Sheet: File: UPD—board.kicad_pcb		F.Cu F.Silk B.Cu B.Silk		D
Title:				
Size: A4	Date:		Rev:	
KiCad E.D.A. kicad 6.0.7-f9a2dced07~116~ubuntu20.04.1

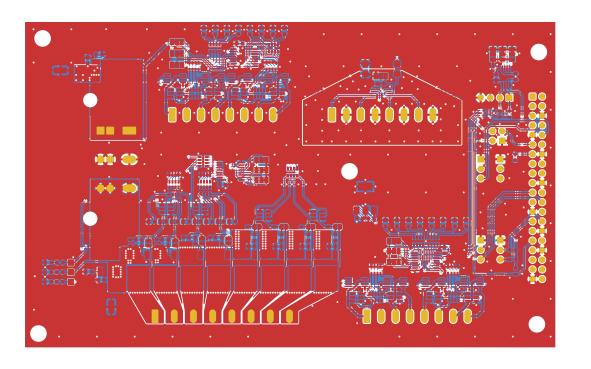
TODO:

Different analog connector Too many vias in high current traces? Different ground plane, need something special for signal ground?

Sheet: F.Cu File: UPD-board.kicad_pcb					
Title:					
Size: A4	Date:		Rev:		
KiCad E.D.A.	kicad 6.0.7-f9	9a2dced07~116~ubuntu20.04.1	ld: 1/1		
4		5

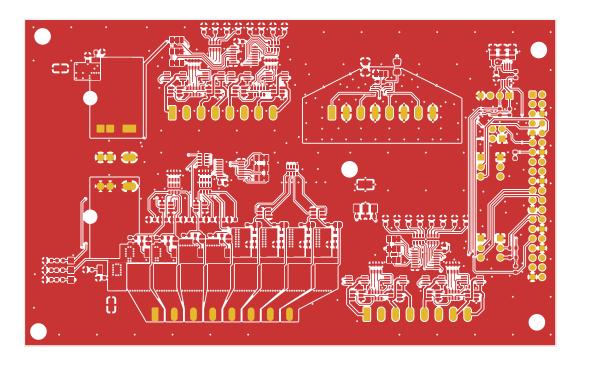
TODO:

Different analog connector Too many vias in high current traces? Different ground plane, need something special for signal ground?
